INTERMOUNTAIN POWER SERVICE CORPORATION

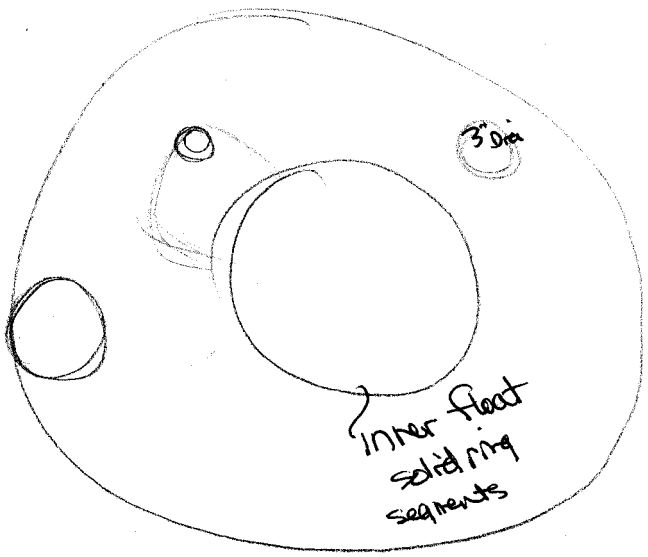
② OD 40 → 39½ attachment

① # coal nozzles → ID 23" Unit 2 # nozzles

23 FS ID size?

③ Scanners push in? angle-cutout Dia Sight Tube

cutoff or push back lighter shroud

④ lighter shroud do we need? fall back - trim 3" - rebracket 4" opening

✓⑤ Sight tube 3"

RJM expansion joints or solid on outer bands?

anchor blades inner & outer ?

Measure: lighter head OD scanner tube dia room - mobility

Spacing blade width
